**VALIDATION THE THEORY OF ADDITIONAL MODULUS OF SUB
GRADE REACTION FOR PAVEMENT OF NAILED-SLAB
SYSTEM BASED ON FULL SCALE TEST:
DEVELOPING THE CURVE OF DISPLACEMENT FACTOR BASED
ON SINGLE PILE NAILED-SLAB**

IJTech-03-89

Response by Authors to Reviewer's Remarks/Comments

DEVELOPING THE CURVE OF DISPLACEMENT FACTOR FOR DETERMINATION OF THE ADDITIONAL MODULUS OF SUBGRADE REACTION ON NAILED-SLAB PAVEMENT SYSTEM (*REVISED TITLE*)

Figure 1 Relationships of δ_0/δ ratio vs. slab deflection for single pile Nailed-slab (Hardiyatmo, 2011b).

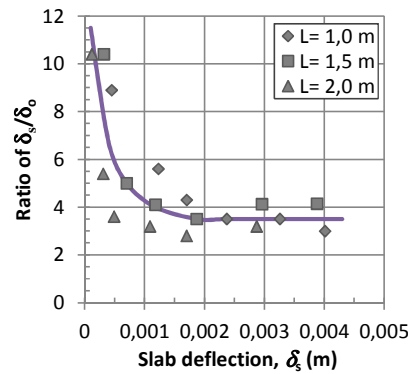
system, not only comparing the results. This is particularly of interest because, in this research, the effect of pile on the overall modulus is relatively insignificant (only 14%). • Sub-Section 5.6: The purpose of this sub-section is unclear, as the flexibility and the bending moment of the slab are not evaluated.
Discussion:	See 'Results'
Bibliography/References:	References • Section 1: Hardiyatmo (2007) not in reference list • Sub-Section 5.3: Hardiyatmo (2001a) not in reference list • Eng-tips Forum is a discussion forum. It is not an appropriate reference for academic papers.
Others:	Editing • The title is too long. Focus on the main message. • Please do English editing • Soil pond = Test pit? • Sub-Section 5.4: Figure 1? (Not Figure 2) Abstract • In general, an abstract should not have references

Others	Editing • The title is too long. Focus on the main message. • Please do English editing • Soil pond = Test pit? • Sub-Section 5.4: Figure 1? (Not Figure 2) Abstract • In general, an abstract should not have references	It is corrected as per the reviewer's comments.

b) Cross section and loading equipment
Figure 2 Schematic diagram of testing investigation.

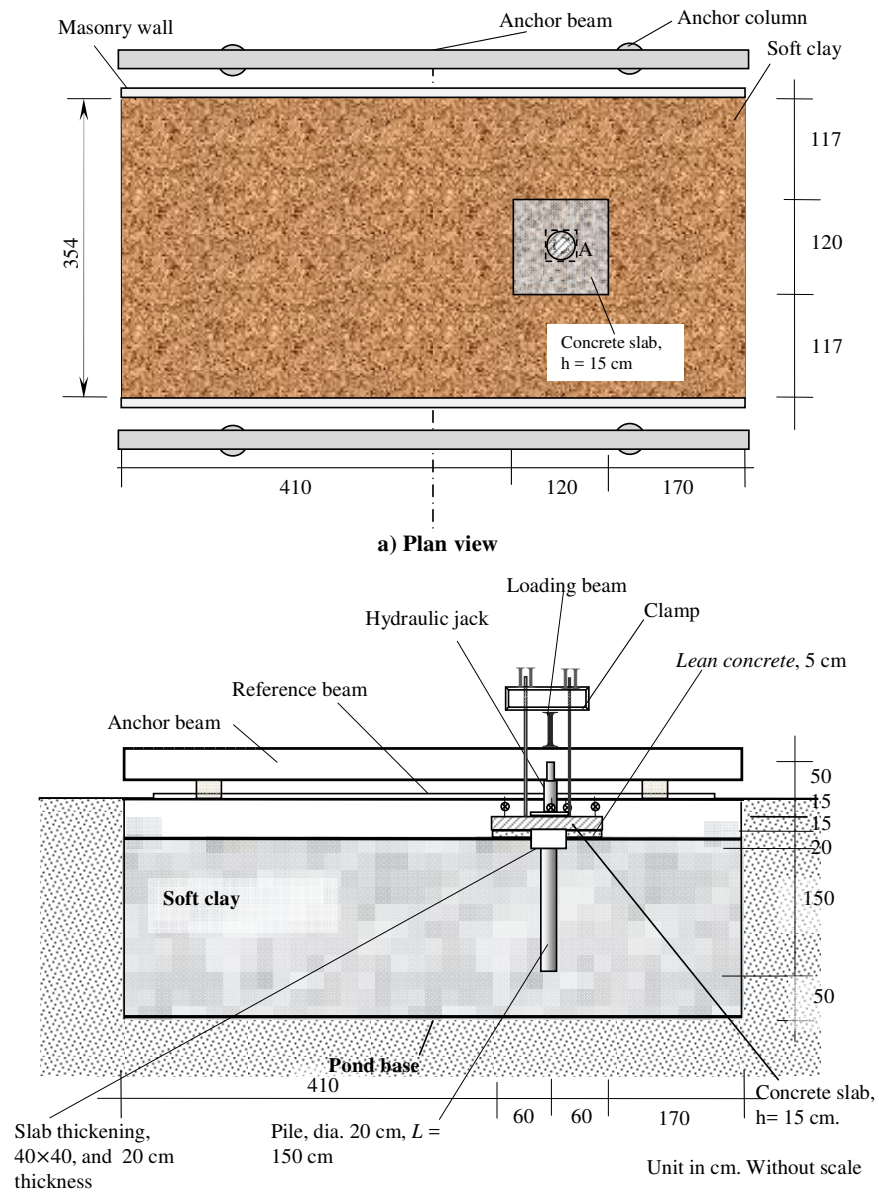
○ Water content for compaction? ○ ... continued CBR test and plate load test after 3 days? Where and why related to lean concrete pouring? Locations of soil investigations should be drawn on Figure 2a. ○ Provide descriptions of types (load ring/load cell/pressure gage? Dial gages/LVDT?) and sketch of locations of monitoring devices? (For example: how to get deltas?)	• Water content for compaction was about 55% and described in the text and fig. 3. • ... continued CBR and plate load test... is delleted. • It is corrected as per the reviewer's comments except sketch of locations.
Results	• Sub-Section 5.1: Stiffness from pile tension load test appears to be greater than stiffness from pile compression load test. This suggests that the pile tip resistance has some influence on the load-displacement curves. Furthermore, as the nailed-slab system is in compression, this suggests that Eq. 2 (relying on shaft resistance) might not be factually appropriate. In fact, in a typical slab on ground – pile system, the pile would experience some degree of negative shaft friction due to the load transmitted by the slab. (Compatibility issue). • Sub-Section 5.2: ○ Slab only test not described yet. ○ 'Since the loading position ... tends to lower': What is the basis for this statement? It appears to be a speculation. • Sub-Section 5.3: 'The average loading pressures and settlement were used': What does 'average' mean? • Sub-Section 5.4: ○ Table 2 should be referred in the discussion? ○ 'Curtain': What does this refer to? ○ 'This curve is similar with ...': The similarity should be discussed further, because they do not look similar for slab settlement >2 mm. • Sub-Section 5.5: ○ 21.21 kPa? Why not 19.82 kPa? ○ Suggestion: Authors to describe	• In this paper, this issue is not studied yet. Hope, it will be studied further in other time. Thank you • Sub-section 5.2 is corrected as per the reviewer's comments. • Sub-section 5.3 is corrected. • Sub-section 5.4 is corrected as per the reviewer's comments. • Ultimate unit friction f_{su} is 21.21 kPa

Figure 4 Single pile test results; a) Axial compression, b) Axial tension, c) Pile unit friction.

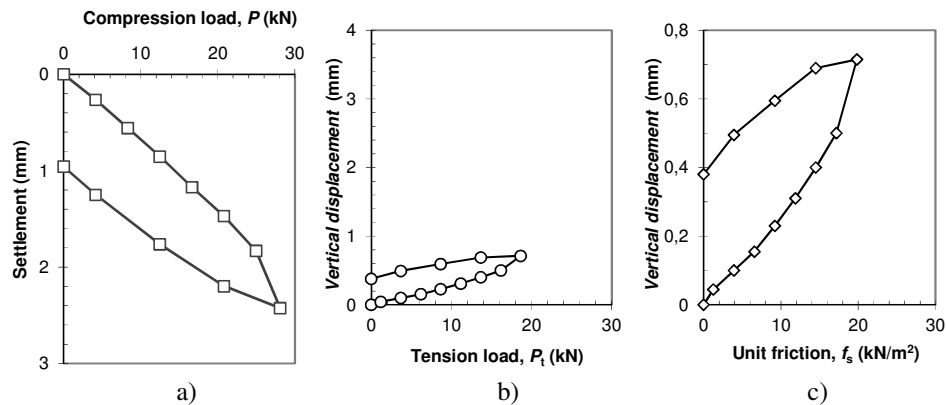
Results:	• Sub-Section 5.1: Stiffness from pile tension load test appears to be greater than stiffness from pile compression load test. This suggests that the pile tip resistance has some influence on the load-displacement curves. Furthermore, as the nailed-slab system is in compression, this suggests that Eq. 2 (relying on shaft resistance) might not be factually appropriate. In fact, in a typical slab on ground – pile system, the pile would experience some degree of negative shaft friction due to the load transmitted by the slab. (Compatibility issue) • Sub-Section 5.2: - o Slab only test not described yet. - o 'Since the loading position ... tends to lower': What is the basis for this statement? It appears to be a speculation. • Sub-Section 5.3: 'The average loading pressures and settlement were used': What does 'average' mean? • Sub-Section 5.4: - o Table 2 should be referred in the discussion? - o 'Curtain': What does this refer to? - o 'This curve is similar with ...': The similarity should be discussed further, because they do not look similar for slab settlement >2 mm. • Sub-Section 5.5: - o 21.21 kPa? Why not 19.82 kPa? - o Suggestion: Authors to describe the general formulation of the

Figure 8: a) The $\Delta k - \delta$ relationship based on several methods, b) The $P - \delta$.

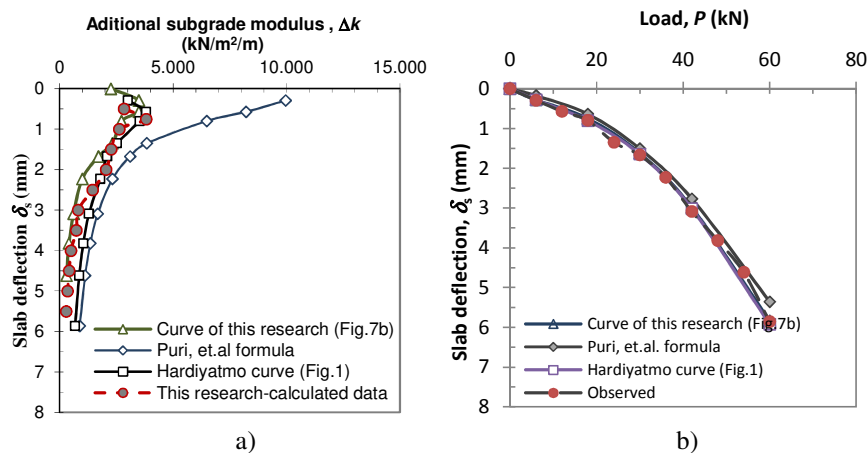
Comment [M12]: What is the rationale taken this value?
